OICA comments on Switzerland proposal (GRBP-74-02)

Switzerland proposal (GRBP-74-02)

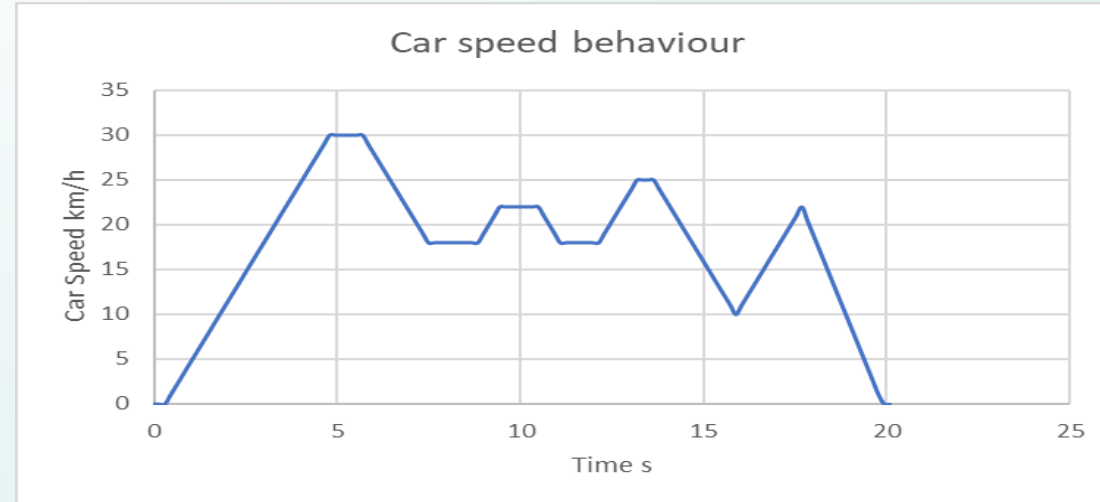
- Switzerland proposes to mandate a cut-off for AVAS above 20 km/h for environmental benefits especially in residential area.
- For Switzerland AVAS sound above 20km/h is a superfluous noise pollution and undermines noise abatement.

- Abrupt cut-off / on will induce for both car cabin passengers and pedestrians a harmful effects:
 - Noise annoyance due to impulse noise effect
 - Additional danger due understanding behaviour.
- The proposal from Switzerland would conflict with the original intent of UN R138 to ensure compatibility with FMVSS 141.
- We further refer to the presentation of the World Blind Union (WBU) GRB-62-16 where concerns were raised that “the proposed AVAS standard does not appear to add sufficient sound to existing electric and hybrid vehicles”.
- We are ready for a revision of UN R138 addressing all these concerns raised by France and Switzerland to outline a clear application range of AVAS. This revision shall as well address the need for a technical revision as suggested by ISO.

Sound comparison of AVAS with/without fade

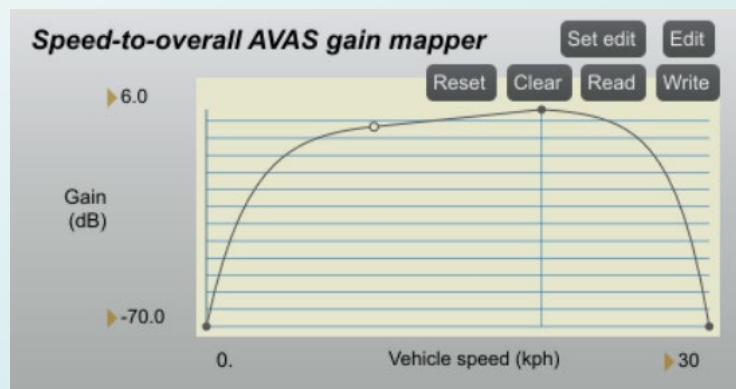
- Audio example (simulation) in residential area with 30 km/h speed limitation:

Vehicle speed simulation based on real driving
